<p>P.O. Box 99 • Ray Brook, New York 12977 • (518) 891-4050</p>	<p>APA Permit <b>95-282C</b> and Order Granting Variance <b>2010-273</b></p>
<p>In the Matter of the Application of <b>STEVEN LOFGREN AND CAROLYN LOFGREN</b> for a permit pursuant to §809 of the Adirondack Park Agency Act and a variance from the standards of 9 NYCRR Appendix Q-3</p>	<p>Date Issued: <b>January 13, 2011</b></p> <p>To the County Clerk: This Permit and Order must be recorded on or before <b>March 14, 2011</b>. Please index this Permit in the grantor index under the following names:</p> <ol style="list-style-type: none"><li><b>1. Steven Lofgren</b></li><li><b>2. Carolyn Lofgren</b></li></ol>

This Permit and Order, issued to Steven Lofgren and Carolyn Lofgren, amends Agency Permit 95-282A to approve the placement of new signage for an existing automobile sales commercial use and grants a variance from the sign standards of 9 NYCRR Appendix Q-3.

**A8**

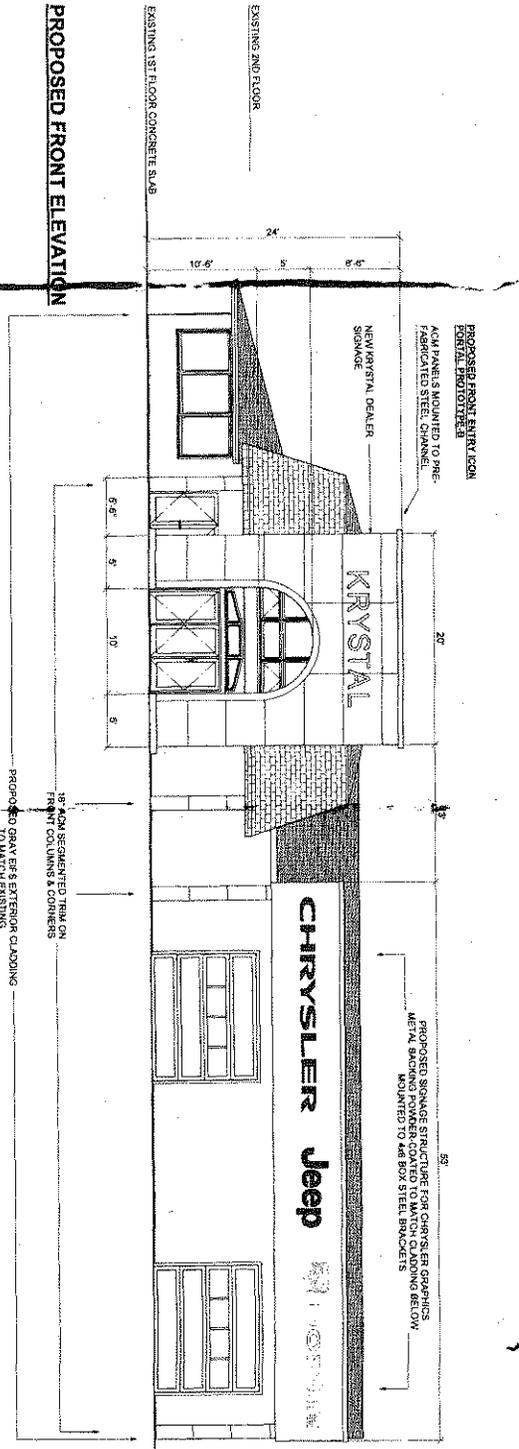
The project as originally proposed is described in Permit 95-282A. The requested amendment, as conditionally approved herein, is for the placement of four new, non-illuminated signs on two portions of the exterior of an automobile dealership building on the project site, as shown on a set of 10 drawings entitled "Krystal Chrysler," drawn by Eric & Eric Drawing Service, and dated March 30, 2010. The first sign

will contain the word "Krystal," at 25.5 square feet in size in black lettering on a gray arch over the entrance to the dealership showroom. The remaining three signs will be placed on a gray board extending 4.4 feet out from the eaves of the roof over the dealership service area: the first sign will contain the word "Chrysler" at 30 square feet in size in black lettering, as signage for the Chrysler dealership; the second sign will contain the word "Jeep" at 22.75 square feet in size in green lettering, as signage for the Jeep dealership; and the third sign will contain the Ram symbol at 8.5 square feet in size and the word "Dodge" at 13.5 square feet in size, both in red lettering, as signage for the Dodge dealership.

A reduced scale copy of Sheet A8 of the drawings is attached as a part of this permit and variance for easy reference. The original, full-scale maps and plans referenced in this Permit are the official plans for the project.

5. This Permit authorizes installation of the signs shown on the plans referenced in the Project/Variance Description as Proposed, and this Order grants a variance for the signage presented on these plans from any inconsistent provisions of Appendix Q-3. No sign besides those described and authorized herein shall be installed on the project site, and no change in lettering or symbols shall occur on these signs, without prior written Agency approval. In addition, external lighting of any signage on the project site shall require prior written Agency approval.
